# **Talbot Mackenzie & Associates**

## **Re: Proposed subdivision at 1322 Rockland Avenue.**

**Assignment:** To review the location of the proposed new driveway off Royal Terrace (see attached site plan) and provide recommendations for mitigating any potential impacts to Garry oak number 373.

Site Plan - Proposed

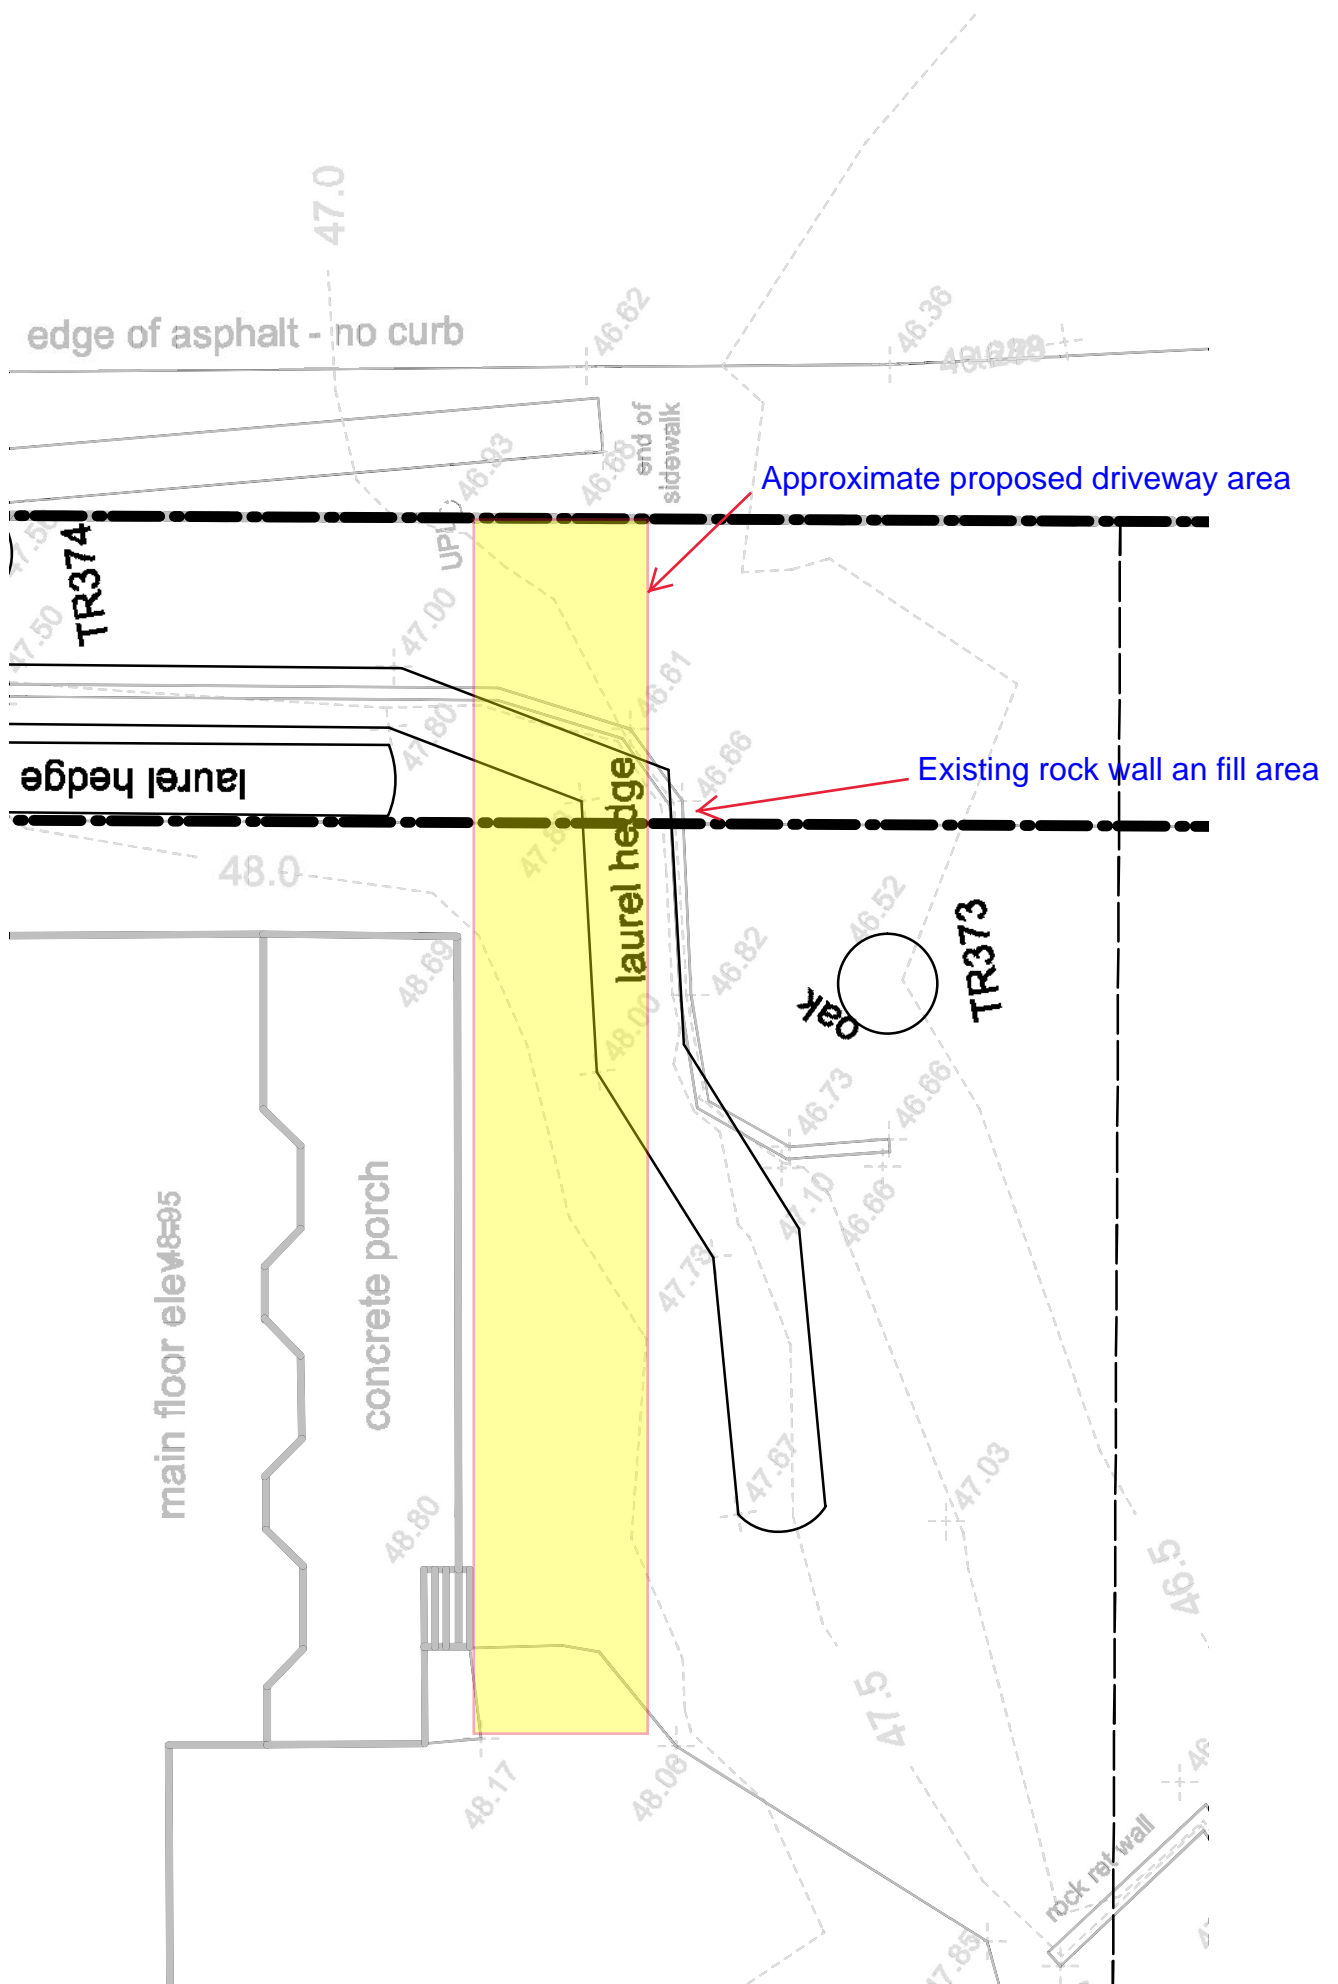
**Observations:** The majority of the proposed driveway will be located within an area that has had a retaining wall installed, fill soil added, and a laurel hedge planted (see attached sketch 1). There will be a portion of the driveway nearest the road on municipal property that will be installed where there is no existing retaining wall.

There is a portion of the proposed new driveway that will be constructed on municipal property in the road dedication area where we do not anticipate encountering significant roots. If during the excavation, roots are encountered that cannot be pruned without negatively impacting the tree, we recommend that floating permeable construction techniques be incorporated, if permitted by the City.

We anticipate that one low sweeping branch approximately 15-20 cm in diameter will have to be pruned to accommodate the new driveway for vehicle clearance, we recommend that the pruning be completed by an ISA certified arborist and do not feel the pruning will have a significant impact on the health of the tree.

**Recommendations:** We recommend that any excavation for the proposed driveway be completed under the direction of the project arborist and may involve a combination of digging by hand and small machine excavation. This will include the removal of any portions of rock wall that must be removed and the removal of the existing laurel hedge. If any roots from Garry oak 373 are encountered during the excavation the proposed new driveway must be designed to retain them.

The amount of fill soil that can be removed without encountering roots from the oak tree will dictate the final design of the new driveway and may require input from a Geotechnical engineer. We recommend using the following floating, permeable driveway specifications or a similar design to minimize any impacts the proposed new driveway may have on Garry oak 373. We do not anticipate that any significant roots will be encountered from Garry oak 374.
